# Access Compliance Report

Intersection ID: 17925	Main Street: CROSS_WINDS_RD	Cross Street: IDLEWILD_RD	Location:	E
ADA ID: C59B9DE2CBF2	Ramp Type: BlendTrans2	Initial Pass/Fail: Fail	Overall Compliance: No	Severity Score: 10

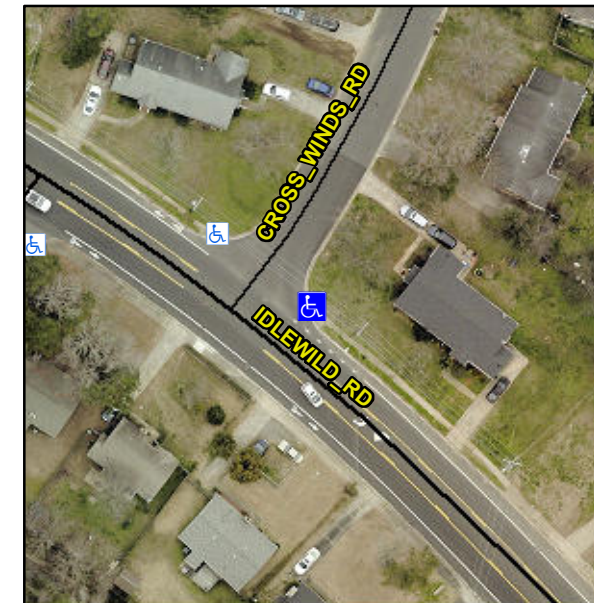
**Not Found, R304.5.1, R304.5.3**

Compliance	Description	Data	Compliance	Description	Data
N/A	Ramp Length (in)	54.0	Yes	BlendTrans Slope (%)	2.8
No	Ramp Width (in)	47.0	No	BlendTrans XSlope (%)	3.5
N/A	Flare Type LT	N/A	N/A	Flare Type RT	N/A
N/A	Flare Slope LT (%)	N/A	N/A	Flare Slope RT (%)	N/A
N/A	Flare Traversable LT?	N/A	N/A	Flare Traversable RT?	N/A
N/A	Landing Length (in)	N/A	N/A	DWS Provided?	N/A
N/A	Landing Width (in)	N/A	N/A	DWS Contrast?	N/A
N/A	Landing Slope (%)	N/A	N/A	DWS Length (in)	N/A
N/A	Landing X Slope (%)	N/A	N/A	DWS Full Width?	N/A
N/A	Landing Curb? (Y/N)	N/A	N/A	DWS Offset (in)	N/A
N/A	Shared Landing?	N/A			
N/A	Gutter Ponding?	N/A	N/A	Gutter Slope (%)	N/A
N/A	Gutter Lip Ht (in)	N/A	N/A	Gutter X Slope (%)	N/A
N/A	Painted X Walk1?	No	N/A	Painted X Walk2?	No
	X Walk 1 Direction	To NW		X Walk 2 Direction	To SW
	X Walk 1 Width (in)	N/A		X Walk 2 Width (in)	N/A
	X Walk 1 Slope (%)	5.2		X Walk 2 Slope (%)	0.4
	X Walk 1 X Slope (%)	0.9		X Walk 2 X Slope (%)	3.1

N/A	Ramp inside XWalk1?	N/A	N/A	Ramp inside XWalk2?	N/A
	Road Slope (%)	3.5		Clear Space?	N/A
	Road X Slope (%)	4.4	N/A	Clear Space to XWalk (in)	N/A
N/A	Any Obstructions?	N/A	N/A	Storm Grate/Utility Hazard?	N/A
	Obstruction Type			Storm Grate/Utility Type	
		N/A			N/A
			Yes	Surface Condition? (G/P)	Good
			No	Curb Slope (%)	19.3

**Remove & Replace Curb Ramp With Two New Directional Ramps or Equivalent.**
